NEW: NON-AMBULATORY ROLLER SYSTEM

NON-AM ROLLER CART SYSTEM

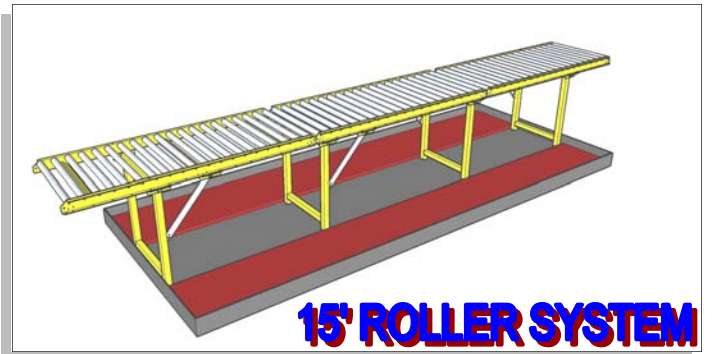
There will be a few changes and improvements over the previous system.

Changes and features of the new System:

1. The 12' system is now a 15' system and consists of three 5' sections rather than two 6' sections.
2. The 18' system is now a 20' system and consists of four 5' sections rather than three 6' sections.

3. The pool size will remain the same, however, the new roller tables will extend about a foot on either end past the Roll-Up Pool. This will offer more stability and room when positioning or removing patients.

4. The system will be lighter considering the all aluminum rollers and construction.
5. Since most teams decon their patients on a backboard, we are now spacing the rollers at 3" on center, reducing weight and cost.

6. The Systems will be available with an "extra rollers option" for traditional, closer spacing.
7. The System will be available in a "cart" configuration or with the traditional fold-out legs. The cart mounted System will offer storage for the non-ambulatory Roll-Up Pool underneath the roller table. The additional Table will neatly stack on top.

8. Due to the light weight of the system the Cart could be stored "on end" for reduced storage space.
9. Straps will be included to secure all the parts during transportation and storage.
